Document No. 5115 SWMP Rev H

STORMWATER MANAGEMENT PLAN

13-17 Pacific Drive, Port Macquarie

Appendix E – Comments Response Schedule

PROJECT: 13-17 PACIFIC DRIVE			
DRAWING TITLE: CONCEPT SERVICING PLAN			
ORIGINAL SIZE: A1	LAND DYNAMICS JOB No.: 5115	DRAWING No.: 0001	REV: I

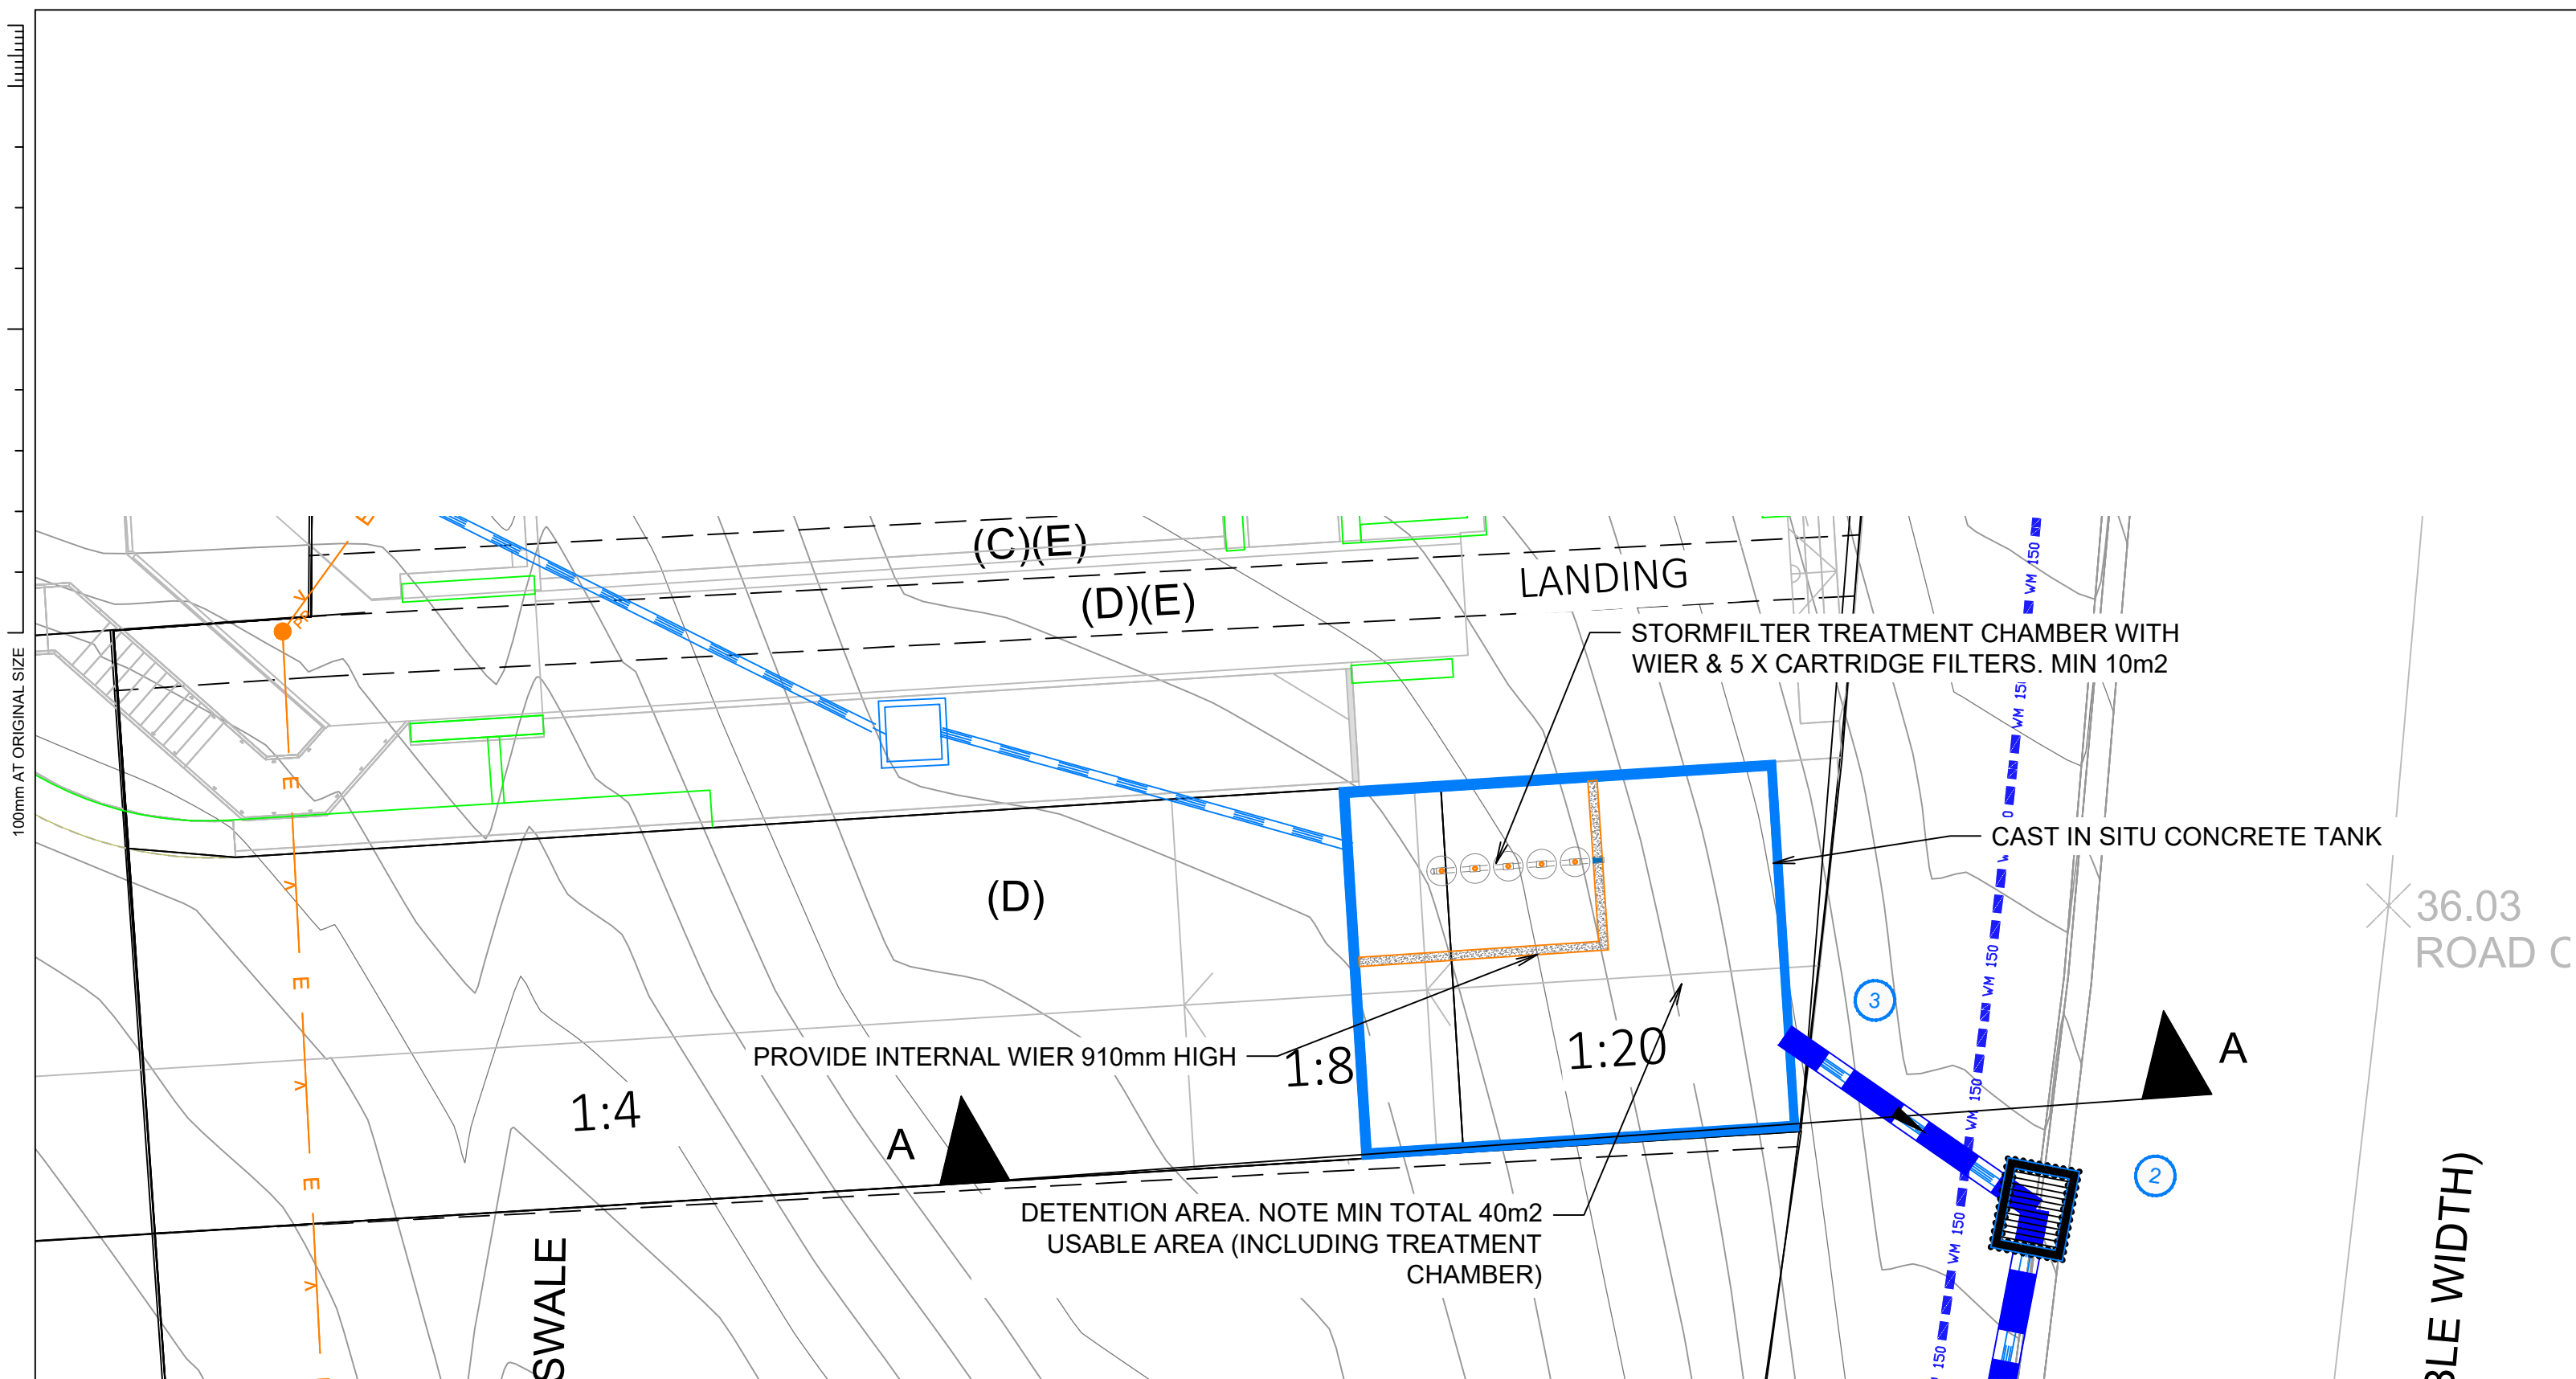
<i>OSD Tank</i>	
16	The Applicant proposes a 64m3 on-site stormwater detention (OSD) tank immediately inside the northern boundary of the Site as shown on the Concept Servicing Plan. Calculations to support the size of the OSD tank need to be provided.	DRAINS model supplied
17	The OSD tank is located in a tightly constrained area that is proposed to be heavily vegetated and is in close proximity to various retaining walls.	Tank location has been moved to under the access ramp
18	Further details including sections need to be provided to demonstrate that it is practical to construct the OSD tank in this location and achieve the landscaping intent. These sections need to show dimensions, thicknesses, clearances to the retaining walls including their footings, etc, in this highly constrained area of the Site.	Tank location has been moved to under the access ramp. Updated drawings with additional details sufficient for DA assessment have been included for the new location

DRAWING TITLE:
CATCHMENT PLAN

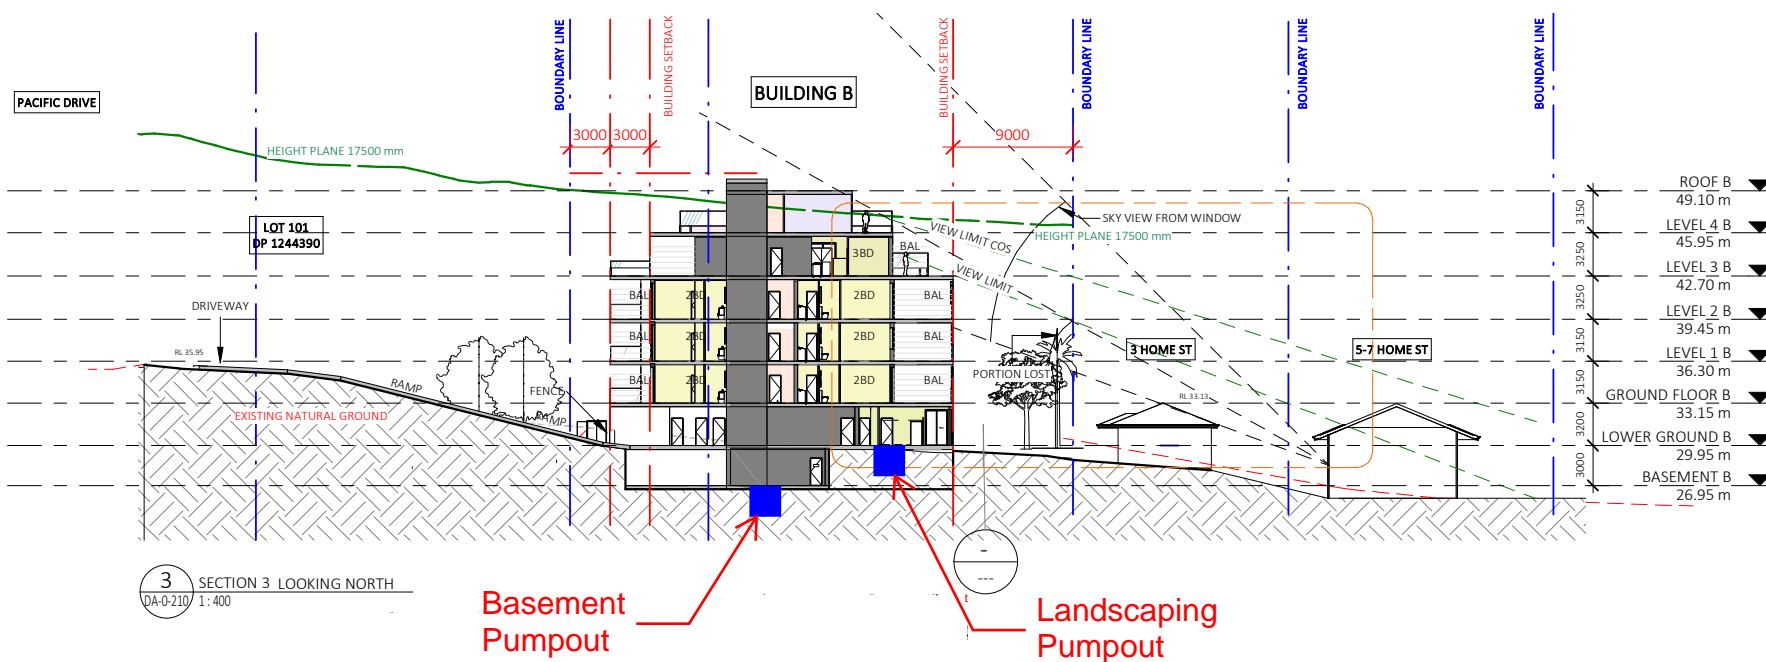
28	Copies of the DRAINS files (with embedded results) are to be provided for review. Clear documentation (and sub catchment maps) for each catchment within DRAINS need to be provided.	Provided with latest revision of report. Catchments shown on concept drainage plans
29	The OSD tank is to be included within DRAINS.	DRAINS model supplied
30	Both existing and developed scenarios are to be simulated.	DRAINS model supplied
31	Allowance for blockage consistent with ARR 2019 is also to be included.	Allowance for blockage not required under AS3500, and internal pit/pipe design is considered conceptual only to prove sufficient fall to OSD tank as per Bewsher comment 25. External public infrastructure proposed does include blockage factors to ARR2019 and PMHC Auspec requirements, although this is considered a detailed design consideration, not a DA requirement
32	The modelling and its accompanying documentation must demonstrate compliance with Council's stormwater standards.	Drains model in accordance with PMHC Auspec requirements
